ND-12-0101

Southern Nuclear Operating Company  
Vogtle Electric Generating Plant Units 3 and 4  
Request for License Amendment: Containment Internal Structural Module  
Shear Stud Size and Spacing (LAR 12-001)

**Containment Internal Structural Module Shear Stud Size and Spacing**

Figure 3.8.3-8 (Sheet 1 of 3)

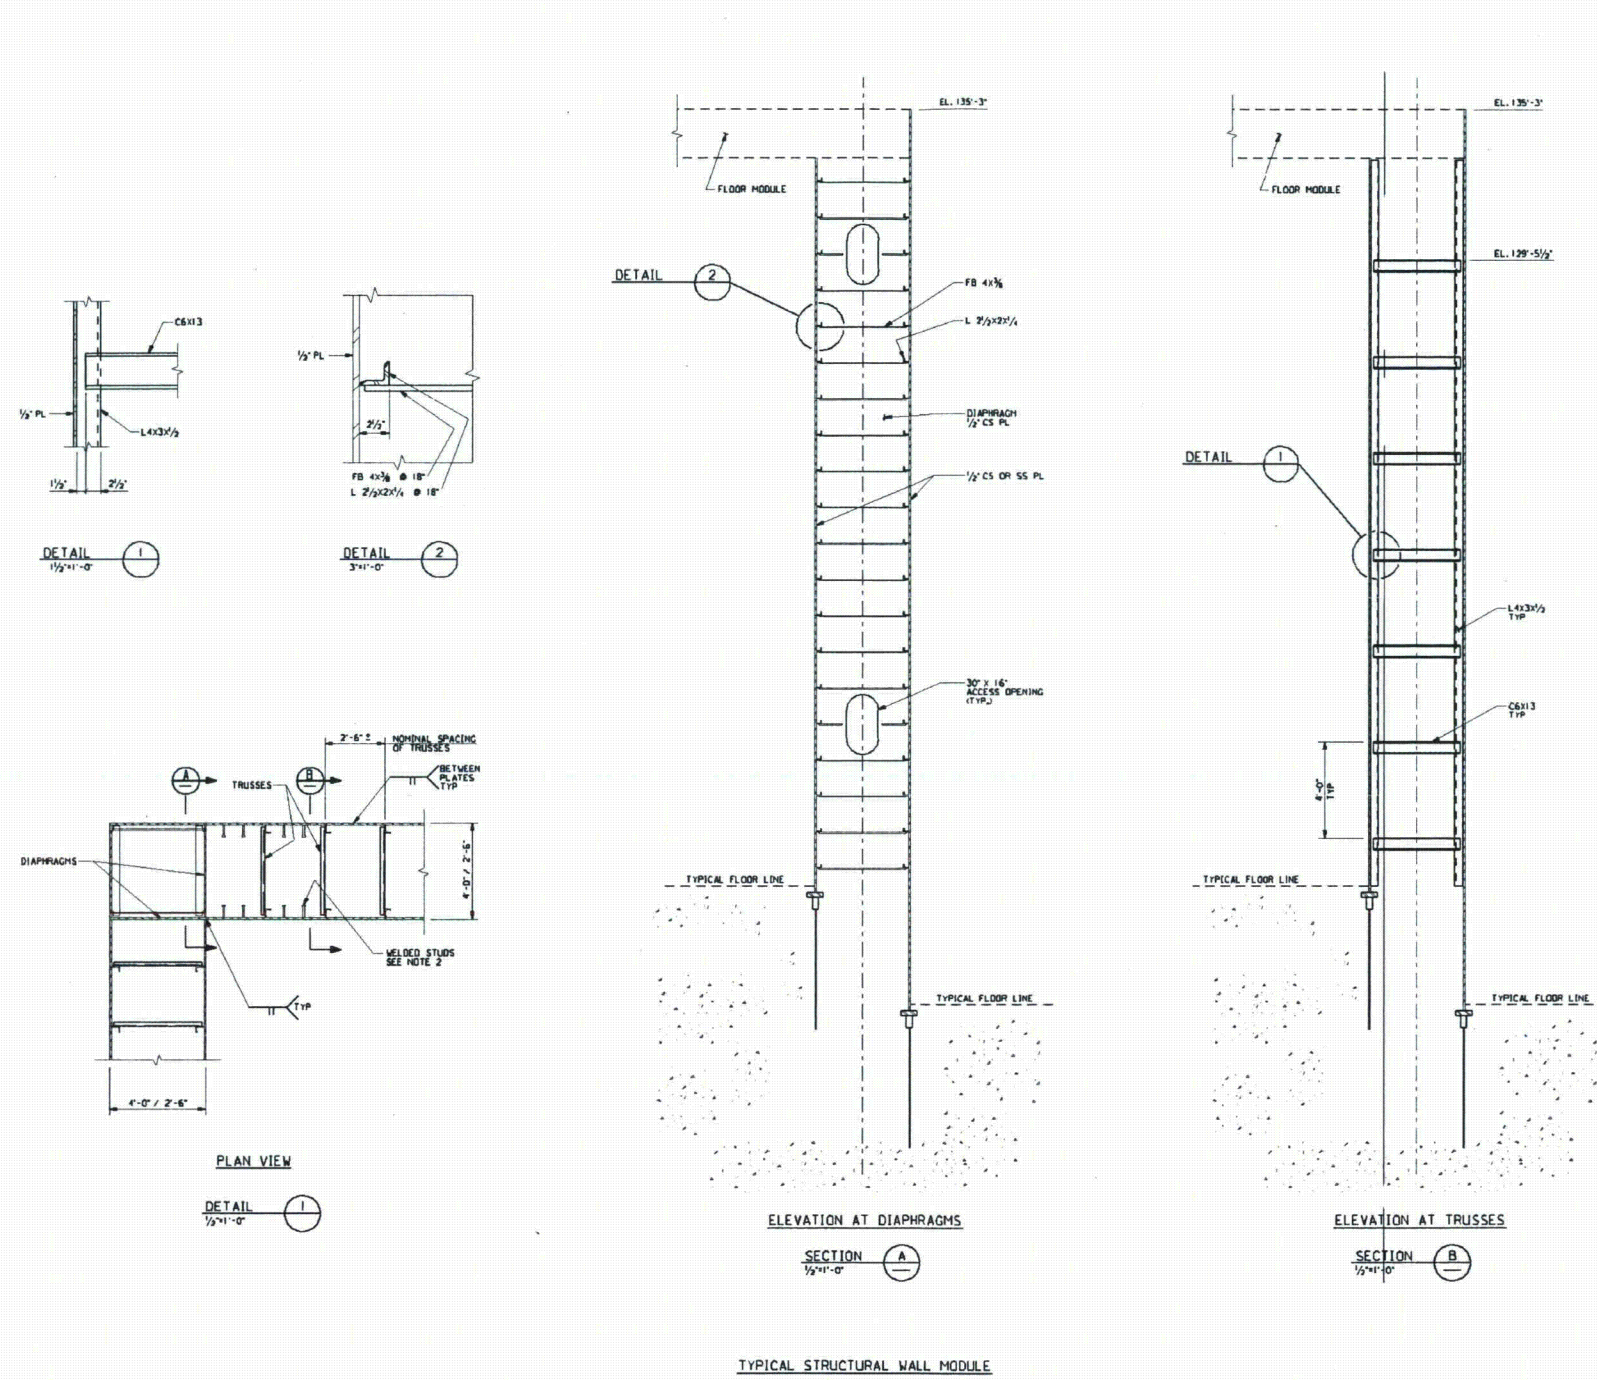
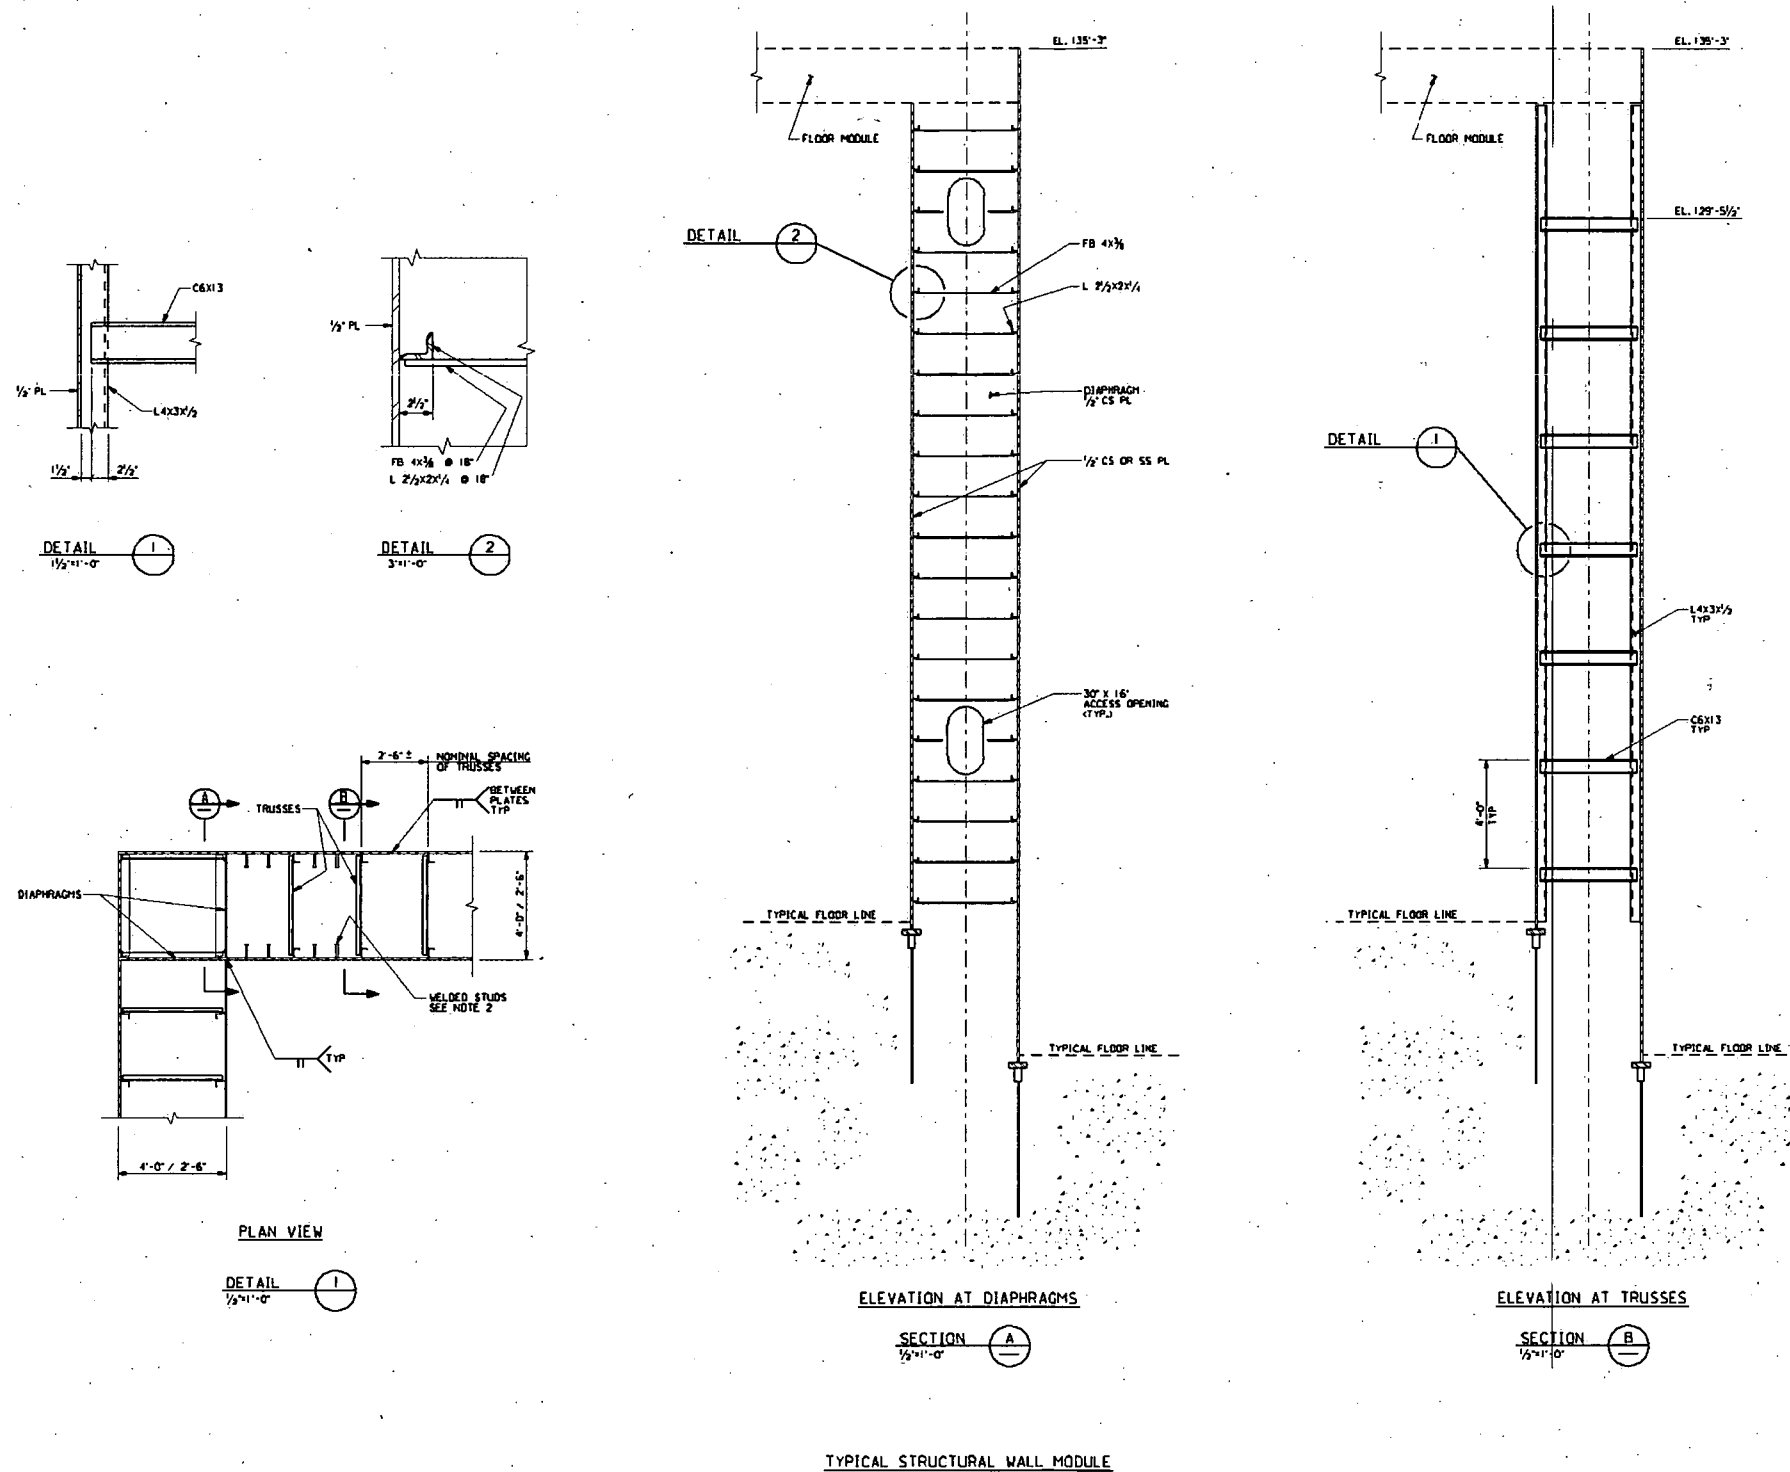
The proposed change would revise Note 2 to plant-specific DCD Figure 3.8.3-8, Sheet 1, which presents typical structural wall module details. This information needs to be changed to be consistent with the design basis calculations. As noted in plant-specific DCD Section 3.8.3.1.3, Structural Wall Modules, the information in the Note is designated as Tier 2\*. The change to Note 2 was inadvertently overlooked when the design basis calculations were previously revised and incorporated into the AP1000 generic DCD.

Plant-specific DCD Figure 3.8.3-8, Sheet 1, Note 2 includes information on the size and spacing of the shear studs in the structural modules. This information needs to be updated to reflect the current design basis. The existing Note 2 shows welded studs for stainless steel plate with 3/4-inch diameter and a spacing of 10 inches horizontal and 8 inches vertical. The design basis calculations show the size and spacing of the studs is 5/8-inch diameter with a 6-inch horizontal by 6-inch vertical spacing. For carbon steel plate, Note 2 shows welded studs with 3/4-inch diameter and spacing of 9.6 inches vertical and 10 inches horizontal. The design basis size and spacing of the studs for carbon steel plate is 3/4-inch diameter with a 10-inch by 10-inch spacing. The change is required to make Note 2 consistent with the design basis. The text of the note is changed to clarify that spacing may be changed to satisfy codes and standards.

Note 2 on Sheet 1 of plant-specific DCD Figure 3.8.3-8 will be revised as shown below.

2. WELDED STUDS SHALL BE SPACED AS FOLLOWS,  
UNLESS ~~NOTED~~ OTHERWISE REQUIRED BY THE  
SPECIFIC CODES AND STANDARDS INVOKED:

$\frac{3}{4}$ "  $\varnothing$  x 6" @ ~~9.6"~~ 10" VERTICAL FOR CS

$\frac{3}{4}$ "  $\varnothing$  x 6" @ 10" HORIZONTAL FOR CS

~~$\frac{3}{4}$ "  $\frac{5}{8}$ "~~  $\varnothing$  x 6" @ ~~8"~~ 6" VERTICAL FOR SS

~~$\frac{3}{4}$ "  $\frac{5}{8}$ "~~  $\varnothing$  x 6" @ ~~10"~~ 6" HORIZONTAL FOR SS

- NOTES:**
1. ALL WORK SHOWN ON THIS DRAWING IS SEISMIC CATEGORY 1.
  2. WELDED STUDS SHALL BE SPACED AS FOLLOWS, UNLESS OTHERWISE REQUIRED BY THE SPECIFIC CODES AND STANDARDS INVOKED:  
 1/2" x 6" @ 12" VERTICAL FOR CS  
 1/2" x 6" @ 12" HORIZONTAL FOR CS  
 1/2" x 6" @ 12" VERTICAL FOR SS  
 1/2" x 6" @ 12" HORIZONTAL FOR SS
  3. THE TYPICAL DETAILS SHOWN REPRESENT THE FUNDAMENTAL APPROACH FOR THE COMPOSITE WALL MODULES. THE FINAL DESIGN DETAILS MAY DIFFER FROM THOSE SHOWN FOR THE FOLLOWING REASONS:  
 • ACCESSIBILITY FOR INSPECTION DURING FABRICATION AND CONSTRUCTION  
 • LESSONS LEARNED FROM IMPLEMENTATION OF THE DESIGN  
 • EASE OF FABRICATION AND CONSTRUCTION  
 • RESOLUTION OF CONSTRUCTABILITY ISSUES AND SEQUENCES  
 • VARIATION IN MODULE SIZE AND CONFIGURATION  
 CHANGES MADE DURING DETAILED DESIGN ARE IN ACCORDANCE WITH THE SPECIFIC CODES AND STANDARDS INVOKED.
